# MORAY FIRTH TRANSPONDER MANDATORY ZONE

STAKEHOLDER CONSULTATION FEEDBACK REPORT ISSUE 2

DATE: 21 JULY 2015

Figure 4. Proposed Moray Firth TMZ (Phases 1 & 2)

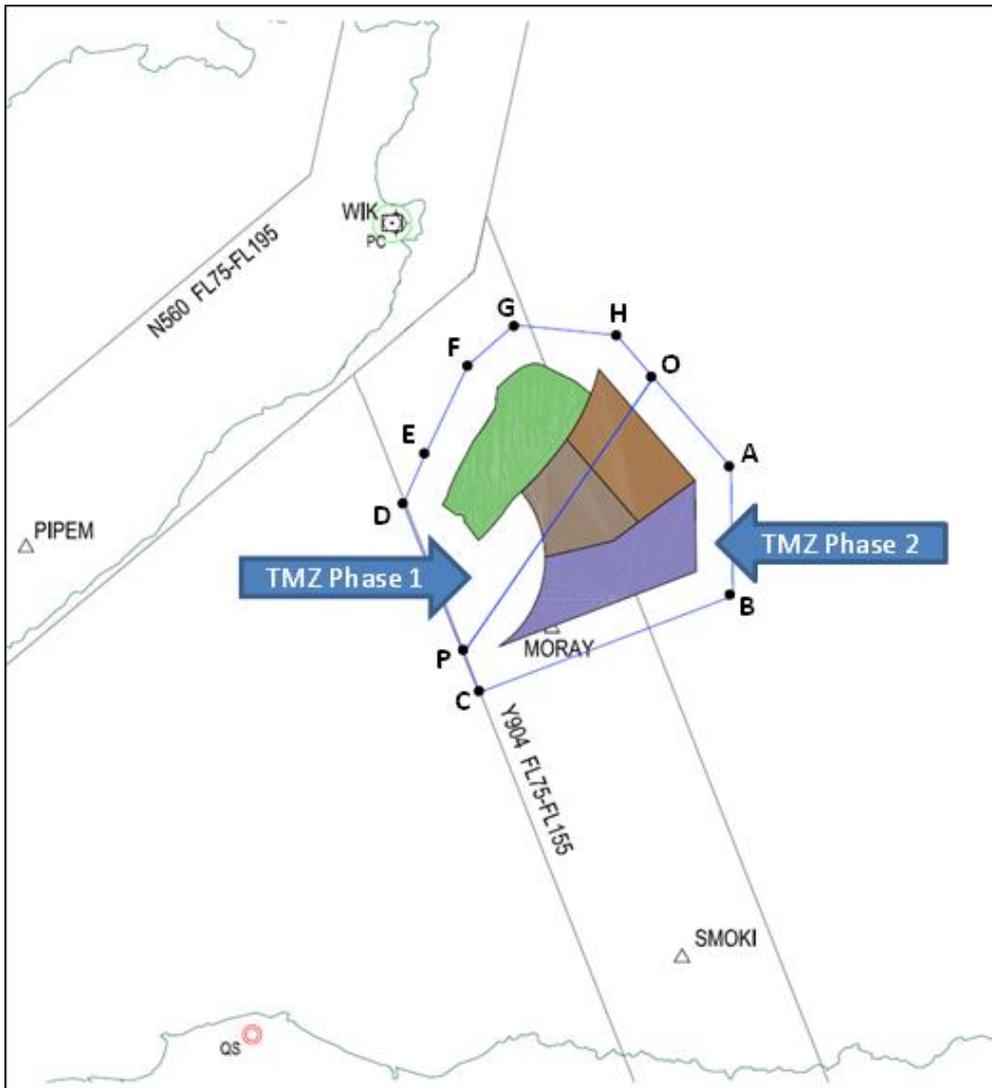
During consultation analysis work was undertaken, in conjunction with the MOD, regarding the likely construction vessel traffic in the wind farm and the potential visibility of these vessels to the RAF Lossiemouth PSR. As a result of this activity, the proposed promulgation date of the Moray Firth TMZ has moved from July 2017 to April 2018, as this date is 3 months in advance of first turbine blade erection and the first visibility of windfarm associated clutter to RAF Lossiemouth.

Concerns regarding the proliferation of TMZs as mitigation for offshore wind farms led the Developers to devise a TMZ promulgation plan which phases the activation of the TMZ in accordance with the wind farm construction timetables. As such, Phase One (shown at Figure 4) would be promulgated in April 2018. The remainder of the Moray Firth TMZ, Phase 2 (illustrated in full at Figure 4) would be promulgated at a later date when MORL has confirmed its construction programme following the award of a Contract for Difference (CfD). This would be no later than 3 months before turbine blade erection commences within the remainder of the development area.

The ACP will request that Phase One (shown at Figure 4) is promulgated initially in April 2018. The second Phase of the TMZ, to include the whole Moray Firth TMZ (shown at Figure 4) will be promulgated no later than 3 months before turbine erection commences within the three consented wind farms within the MORL zone. This phasing of the TMZ is designed to limit the impact on local airspace users as much as practicable. The proposed coordinates of the TMZ are in Table 1.1.
